Office Action Summary

10/027,458

BYRON ET AL.

Fig. 15.

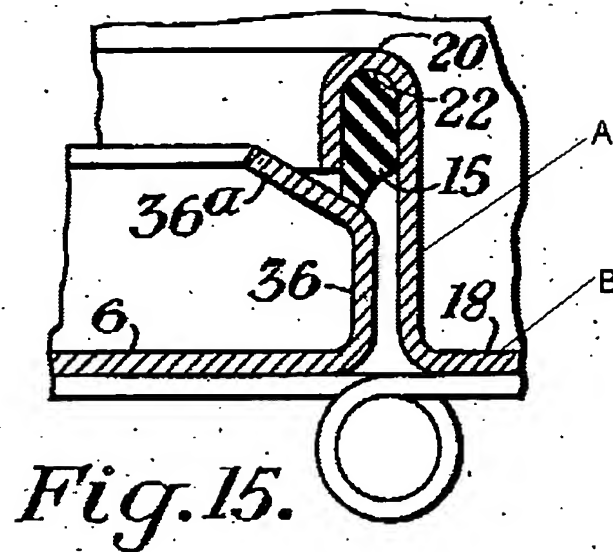
4. Applicant's arguments filed 14 June 2004 have been fully considered but they are not persuasive. Applicant argues that the modification of Rennie et al. in view of McWhirter would not produce the cabinet defined in amended claim 1 because McWhirter fails to teach a second member connecting the first member to a wall as well as a channel attached to the door and extending over the hinge. However, Figure 15 of McWhirter clearly shows a first member that is parallel to the cabinet wall (note A below) as well as a second member connecting the first member to the wall (note B below). With respect to the channel of McWhirter, the channel 22 (Fig. 15) is attached to the door via the hinge and extends over the hinge. Therefore, the teachings of Rennie et al. in view of McWhirter teach all the limitations recited in amended claim 1.

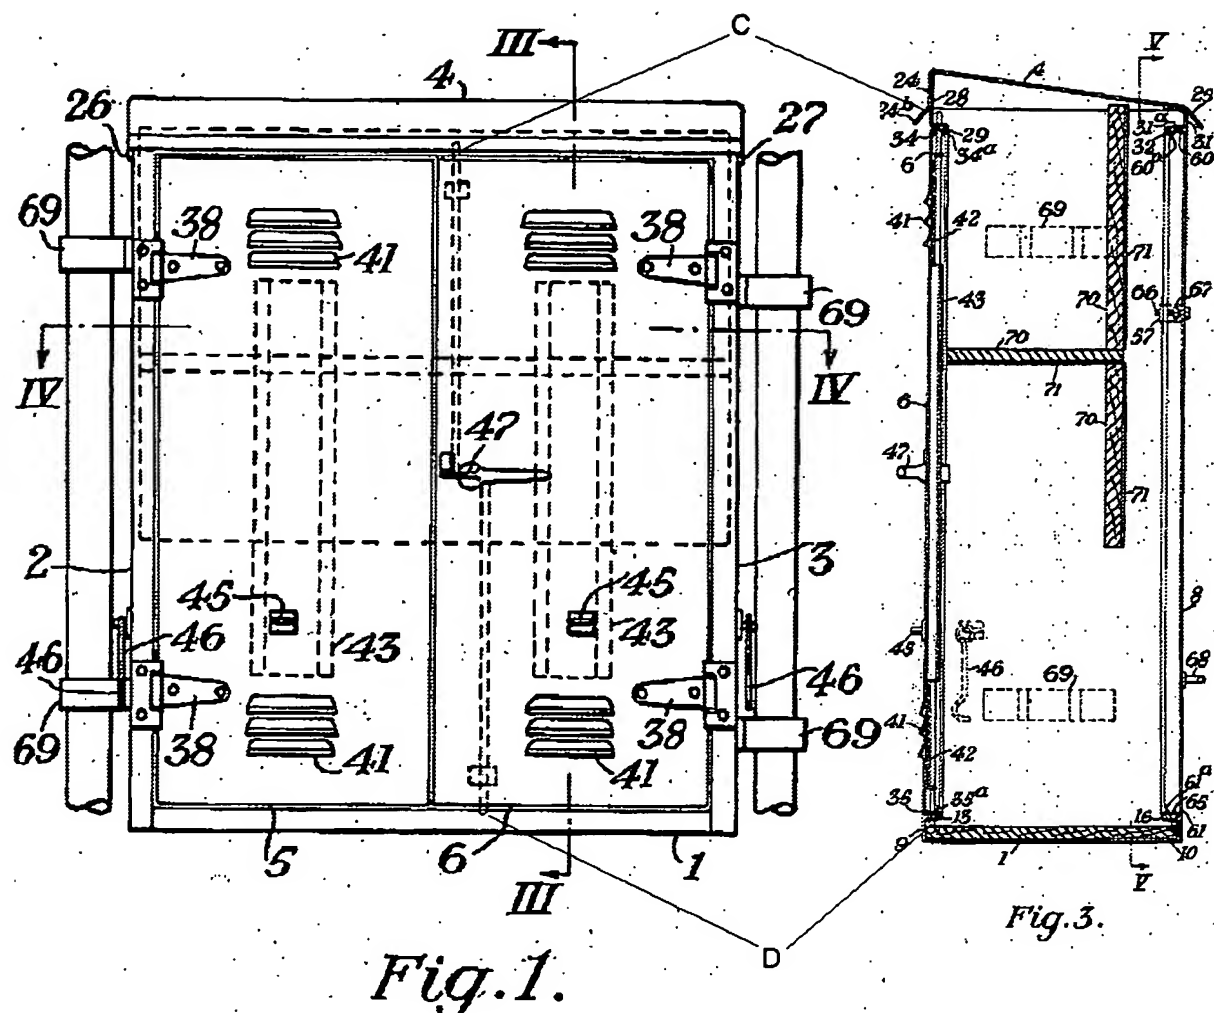
Next, Applicant argues that McWhirter fails to teach a latching mechanism having a plurality of latch hooks and a strike assembly receiving the plurality of hooks.

Applicant mistakenly interprets hook 46 of McWhirter as the plurality of latching hooks.

Figures 1 and 3 of McWhirter clearly show a latching mechanism having a plurality of

latch hooks (note C and D below) received by a strike assembly. Therefore, the

teachings of Rennie et al. in view of McWhirter teach all the limitations recited in claims

8 and 11.
